**Bottom Ash Pond – Trimble County
Station Assessment Report**

**Lockheed Martin
Contractor for the USEPA**

September 2009

Photo #1: Wave erosion, East embankment, downstream slope, looking North

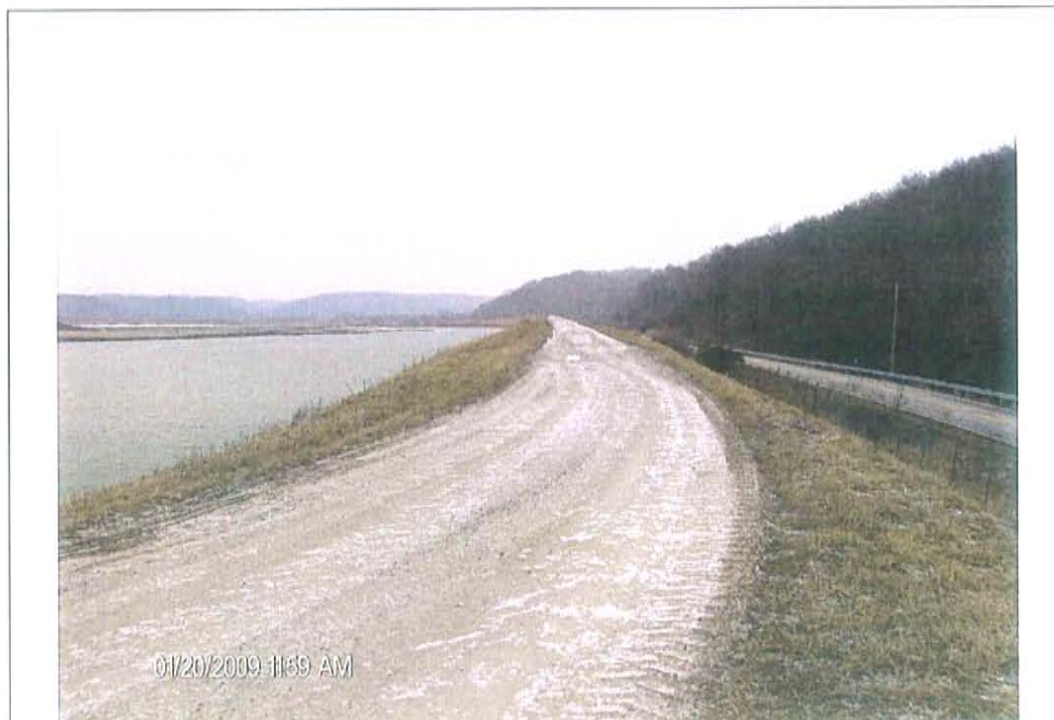
11	Moderate	1, 3, 5	Upstream Slope	Evaluate and repair wave erosion along east and south slopes
12	Normal	--	Toe	Monitor wet area at toe of south slope, east side
13	Moderate	N/A	General	Conduct visual inspection of facility during 2009 growing season
14	Normal	N/A	General	Prepare Operation and Maintenance Plan for all aspects of structure
15	Moderate	N/A	General	Prepare Emergency Action Plan (EAP) for structure distress scenarios
16	Normal	N/A	General	Prepare current topographic mapping
17	Moderate	N/A	General	Institute and document regular structure inspection plan
